SERVICE BULLETIN

SERVICE BULLETIN		No.: MSB-97E55-001	
		Date: 1998-04-15	
Subject: CHANGE IN AIR GAP FOR A/C COMPRESSOR		<Model>	<M/Y>
		(EC,EXP) 3000GT	96-10
		(Z10	96-10
		(EX,EXP) L400	96-10
Group: HEATER, A/C & VENTILATION		(PA0V)	96-10
Draftno: 97-AL-021		(EC,EXP) COLT	
		(CJ0A)	
INFORMATION	OVERSEAS SERVICE DEPT	<i>R. Usami</i>	(EX,EXP) LANCER
		R. USAMI - MANAGER	(CK0A)
		QUALITY INFORMATION ANALYSIS

This Service Bulletin informs you of change in air gap of the clutch for the A/C compressor.

4. INSTALLATION OF ARMATURE PLATE

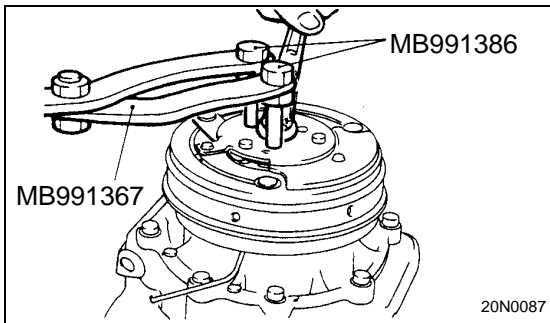
Align the mating mark of the crankshaft spline and the mating mark of the armature plate, and then fit them together.

• AIR GAP ADJUSTMENT

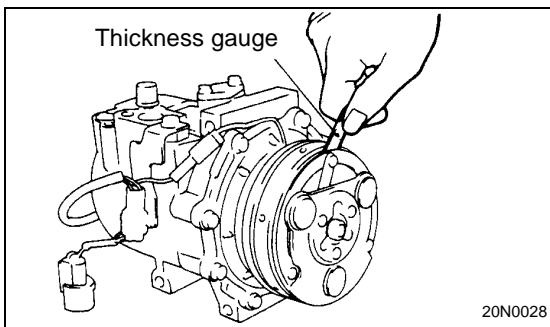
<New>

0.3 - 0.5 mm (0.01 - 0.02 in.)

0.4 - 0.65 mm (0.02 - 0.03 in.)

<Old>

Check whether or not the air gap of the clutch is within the standard value.

If there is a deviation of the air gap from the standard value, make the necessary adjustment by adjusting the number of shims.
